RE: Woodlands at Belmont Hills II Condominium Trust: Appeal of Denial of Zoning Enforcement Request Pursuant to G.L. c. 40A § 15.

Re: ARC Drainage Design: Detention
Basin and Zoning Bylaw Compliance

Re: McLean Hospital – Upham Bowl Storm Water Detention Improvements
Request for Zoning Enforcement

Vannise Hungen Brustin, Inc.
Figure 1
Arc Senior Living Project
Proposed Drainage Areas
Scale: 1"=160'
Date: 03/08/01

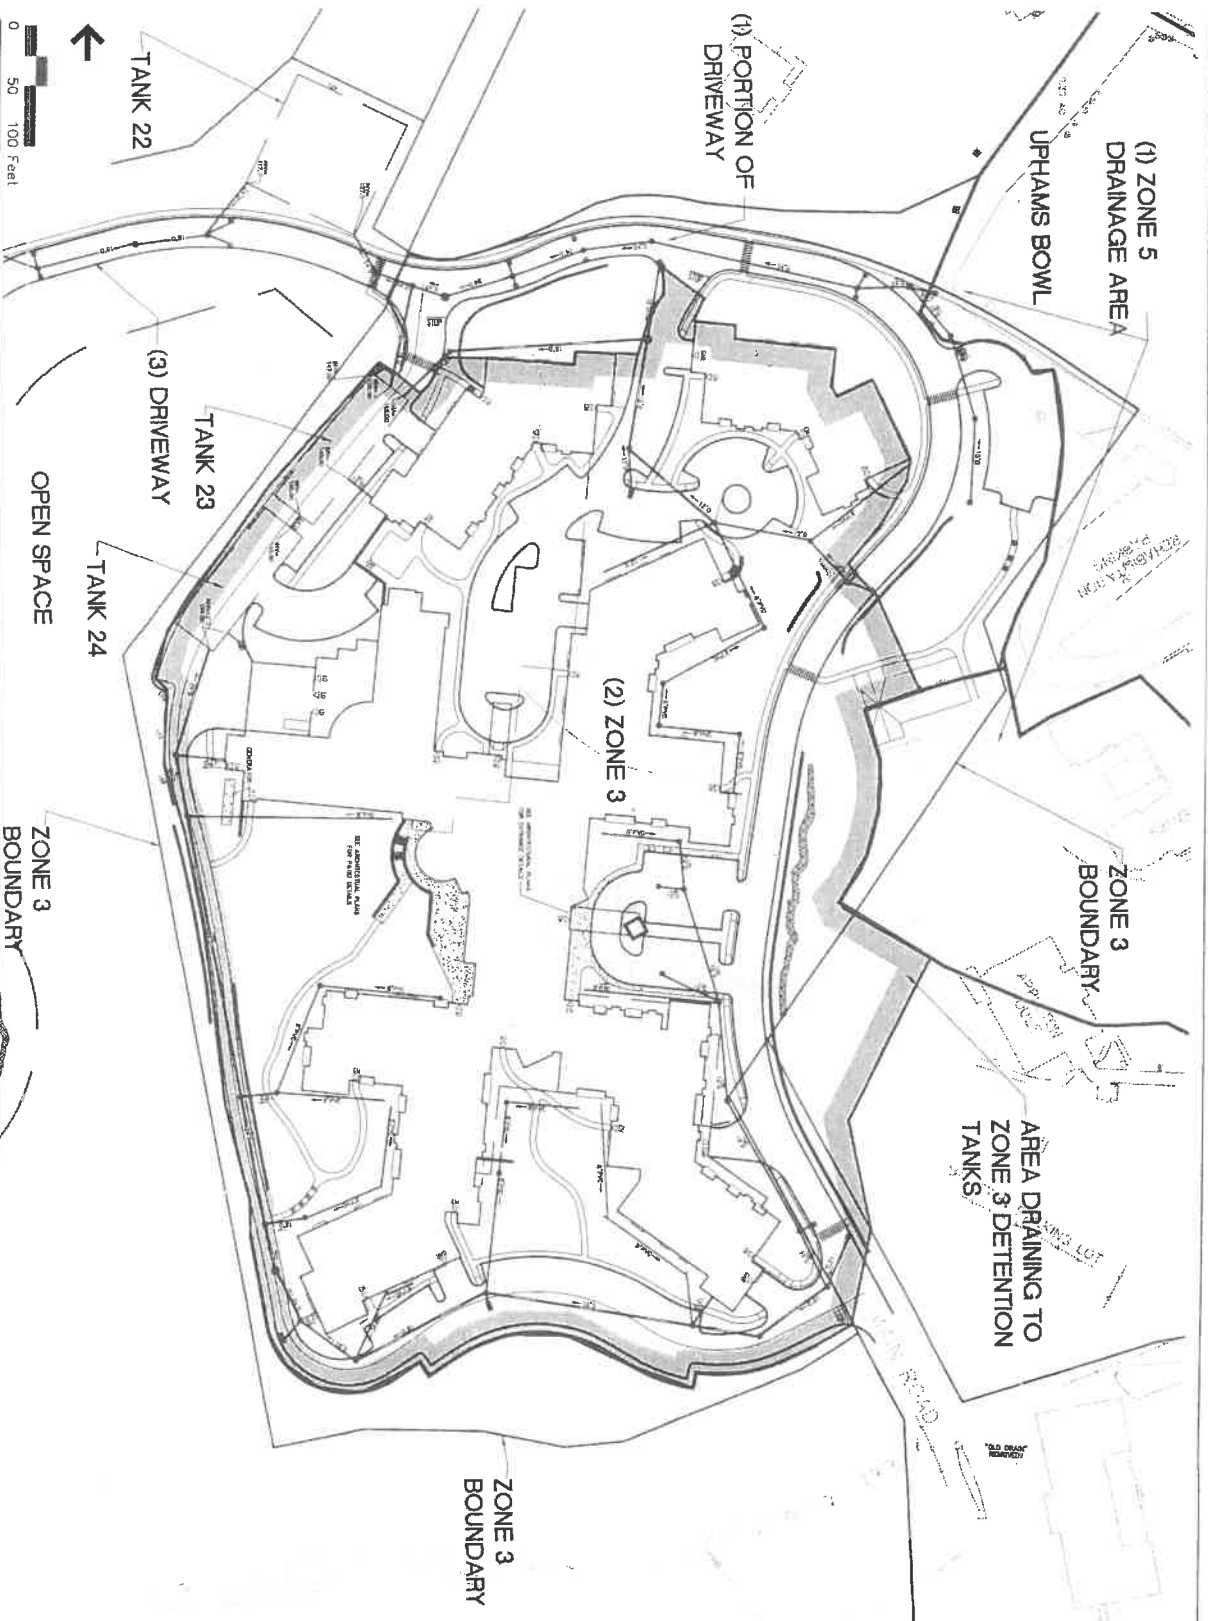
In order to manage storm water runoff as required by Section 6A.5 of the McLean Bylaw, four underground detention tanks (basins) are proposed to temporarily hold runoff and provide a controlled discharge of storm water over extended periods of time. Four tanks, rather than one or two very large tanks, are proposed in compliance with Zoning By-law Section 6A.5(d)'s policy against "accumulation and the need for larger structures." Detention tanks 23 and 24, located in Zone 3, handle the storm runoff from the Zone 3 development area, Drainage Area (2). Detention Tank 11, located adjacent to Trapelo Road at the location of the existing detention area, handles runoff from the access driveway within the Open Space, Drainage Area (3). Each of these detention tanks is designed to mitigate the peak storm water flows from the drainage area served and the zoning district where they are located. These tanks ensure that pre-development peak flow rates are maintained. These tanks, the drainage areas they serve, and the zoning districts in which they are located are shown on the accompanying Figure 1.

Detention Tank 22, located within the Open Space area southwesterly of Zone 3, collects the runoff from the "uphill" Zone 5, Upham Bowl area, and a portion of the proposed driveway running through Zone 3 and is designated Drainage Area (1) on Figure 1. Less than 2 % of the total volume of runoff from area (1), Tank 22 comes from the proposed increase in the impervious area from the driveway referenced above. As there is no new development currently proposed for Zone 5 or the Upham Bowl, and the new driveway replaces the existing driveway with an improved storm drainage system, no mitigation of increased storm water flows is required. However, existing runoff from this area reportedly has resulted in drainage problems on Trapelo Road. In response to requests from Tom Galzarus, Detention Tank 22 was proposed to attenuate the existing peak flows from Zone 5 through Upham Bowl to improve the drainage situation at Trapelo Road. We have been informed that Mr. Galzarus is of the opinion that Tank 22 is the appropriate engineering solution to this situation.

Utility Plan

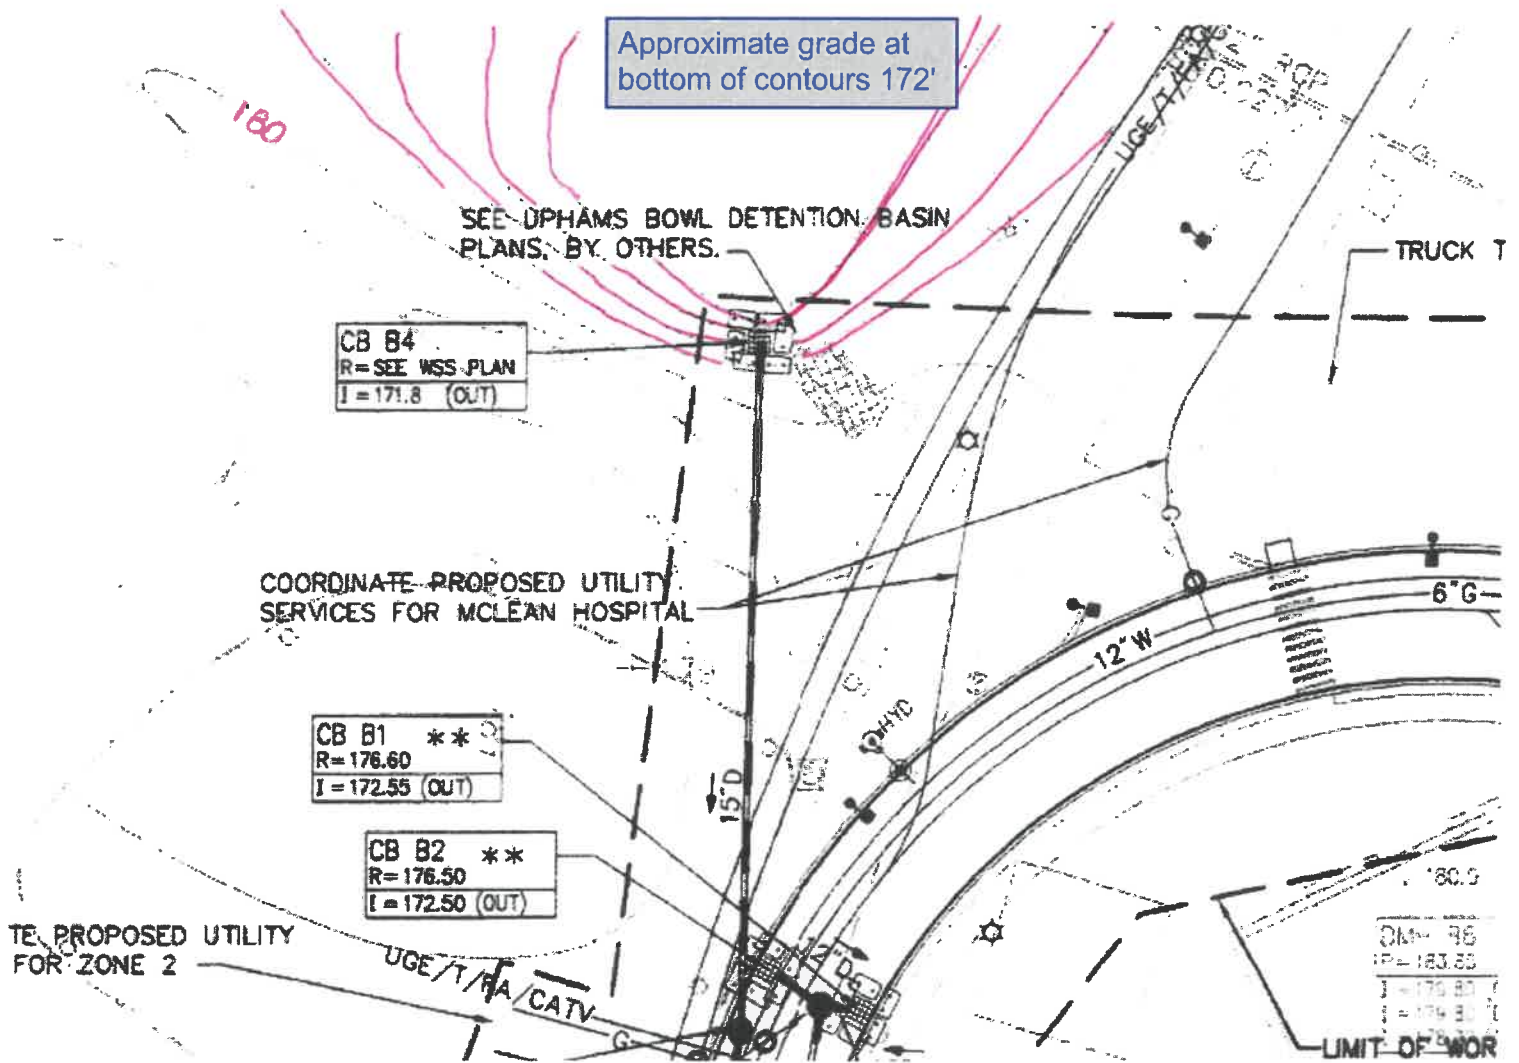
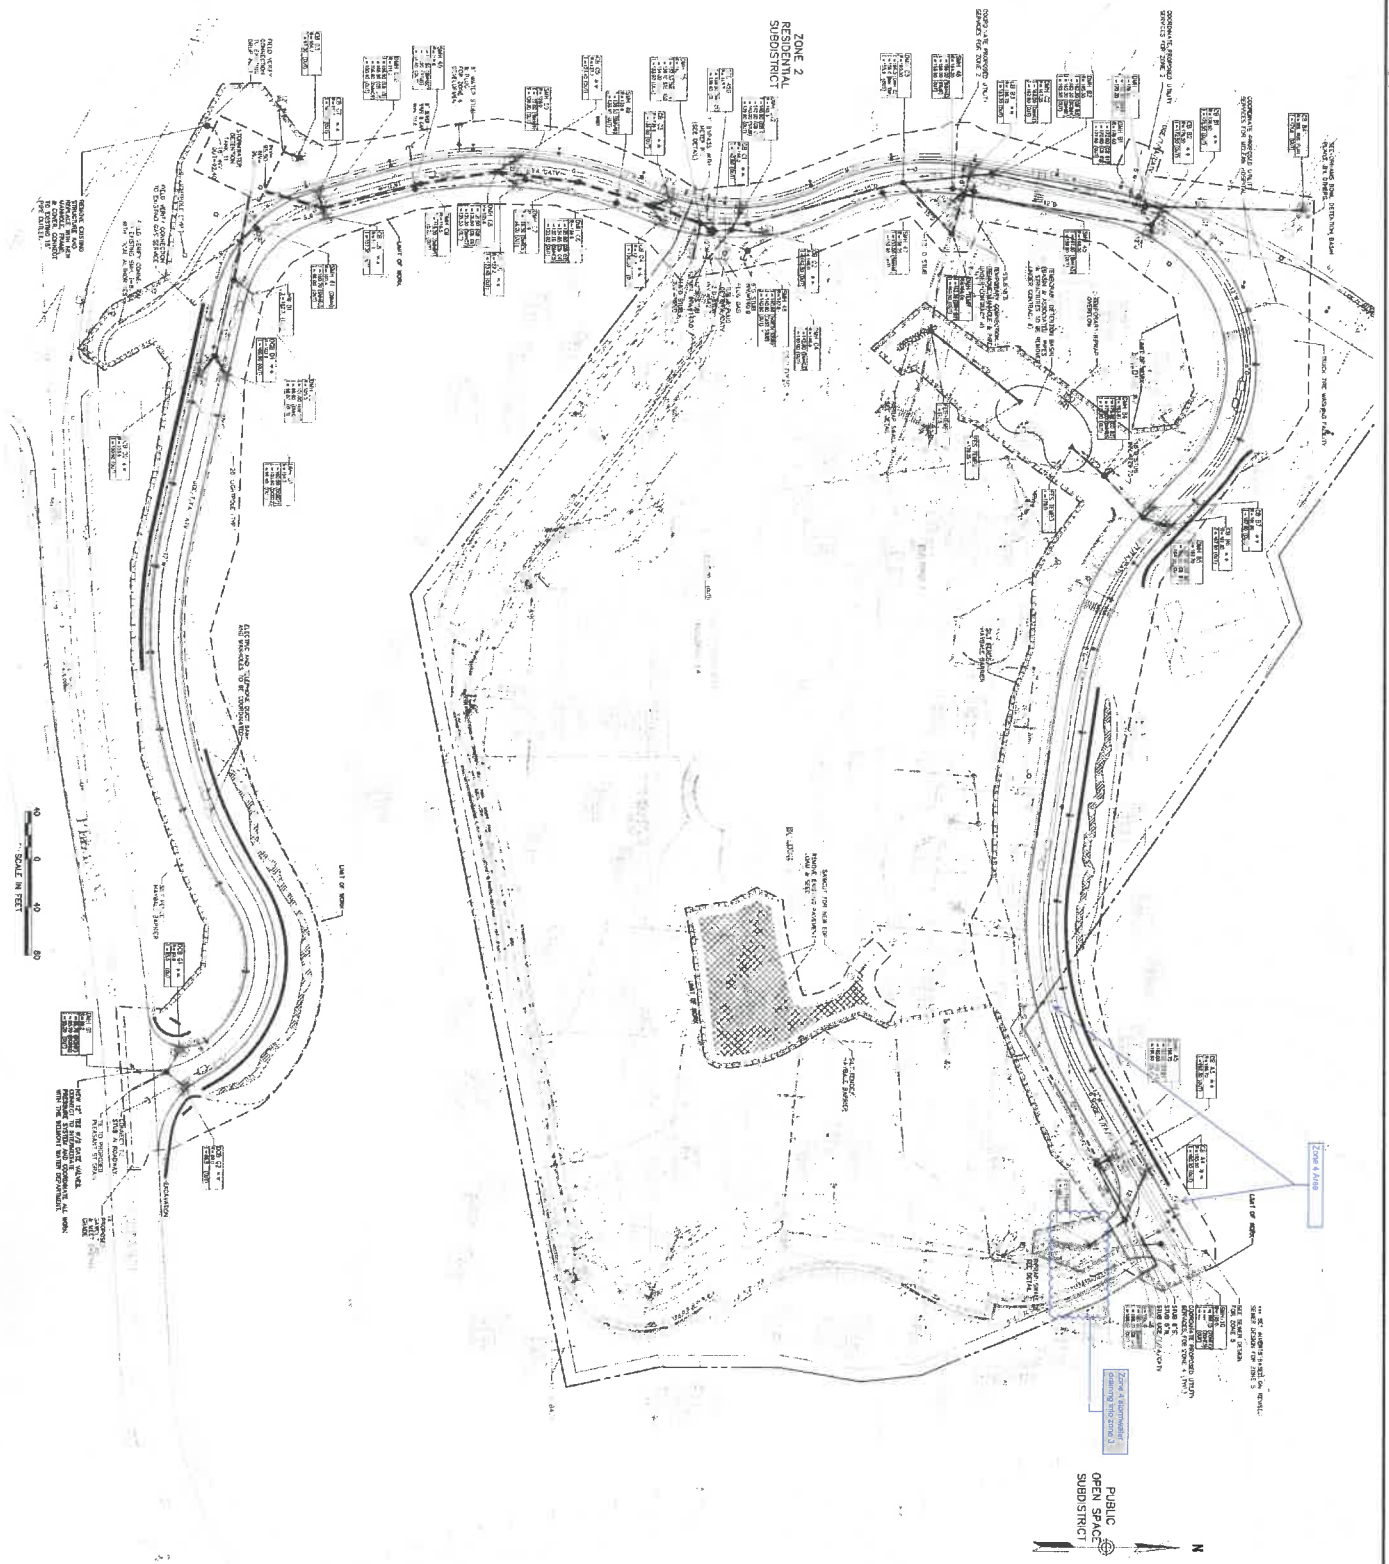
- On the attached blow-up of Drawing C-5 (Attachment D) Catch Basin CB-B4 is indicated adjacent to an area designated by the note "SEE UPHAMS BOWL DETENTION BASIS PLANS BY OTHERS", the plan clearly shows contours indicating a detention basin with an approximate six to eight foot depth, which would allow for a significant amount of stormwater detention, contrary to the zoning approvals and the design intent on the Construction Documents catch basin CB-B4 was installed at an existing low point in in Upham Bowl. This contributes to an increase in the post-development peak stormwater discharge rate, and most likely exceeds the capacity of Stormwater Structure 11 which design relies on the upgradient detention of the Upham Bowl discharge to address Zone 5 stormwater. As far as we are aware the Town has not been able to produce any documents indicating that the Upham Bowl stormwater receives any treatment to meet Stormwater Management Standard 4, for removal of Total Suspended Solids prior to discharging into the Town's municipal stormwater system. Along with being violations of the DEP standards these oversights are violations of the Site Plan Approval conditions related to Stormwater Management within each Zone.

- Also, on Drawing C-5 the temporary outfall, FES TEMP4 was not constructed in accordance with the Construction Documents, this section of the stormwater system collects stormwater from upper Olmsted Drive in Zone 4, and without detention conveys the discharge into Zone 3, which is a violation of the By-Law requiring all stormwater being treated within each specific development zone, it also increases post-development flow to the east. This outfall was submitted and approved as a temporary measure however in the currently pending Zone 3 Site Plan Approval this small system is being treated from an engineering standpoint as a pre-existing condition and detention of this outfall is not reflected in the current design.

C-4
3 of 11
10/1/00

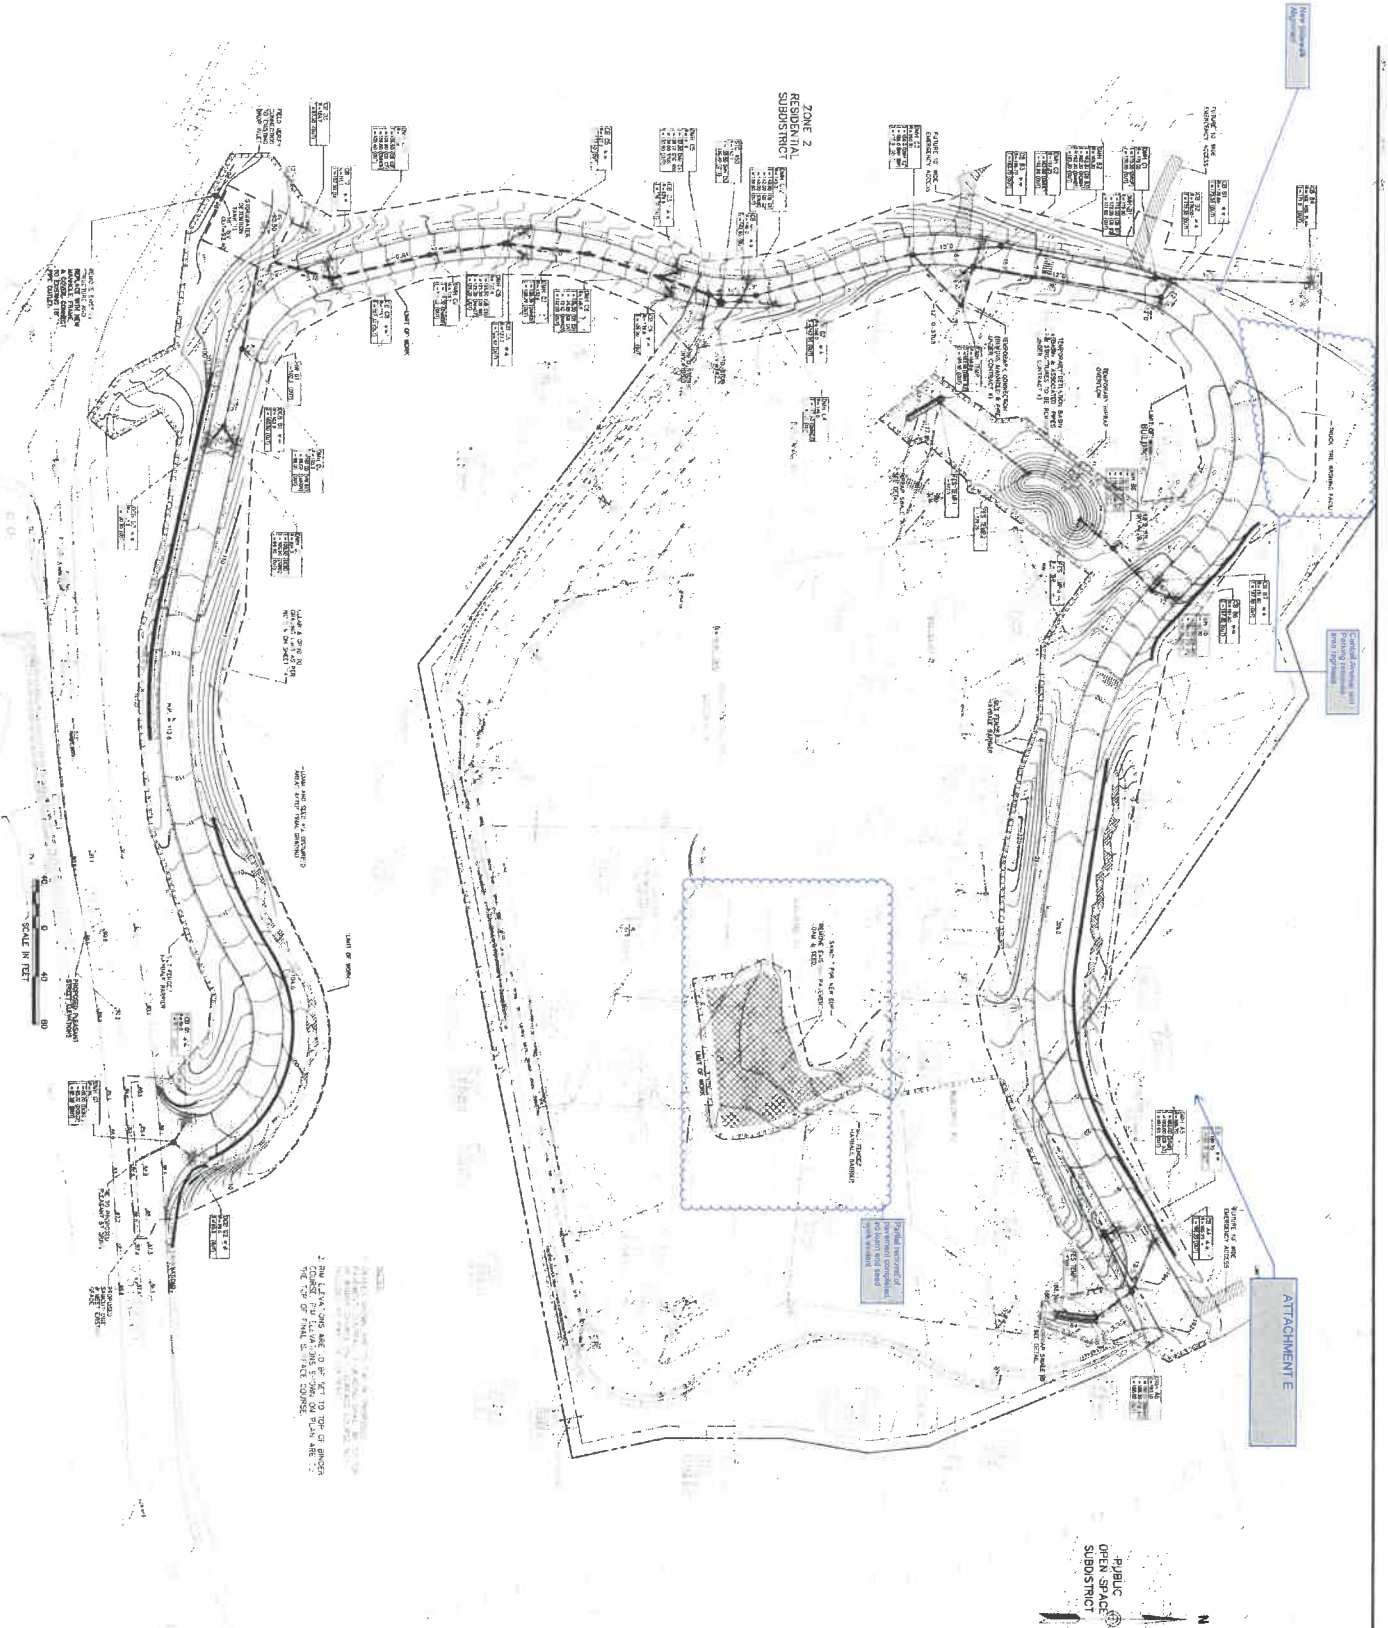
- On Drawing C-4 (Attachment E) the area highlighted as "Remove Existing Pavement Loam & Seed", also the area indicated as "Truck Tire Washing Facility", indicates the removal of the previously existing Central Street and parking area from the MRI Facility to Olmsted Drive and a new sidewalk alignment. The removal of these two sections of previously installed impermeable surfaces were necessary support work to arrive at the .57 Acres of new impervious surface which the interim stormwater design calculations were based (Attachment C). This contributes to an increase in the post-development peak stormwater discharge rate, a violation of the Massachusetts Stormwater Management Standards, and a violation of the Site Plan Approval Conditions.
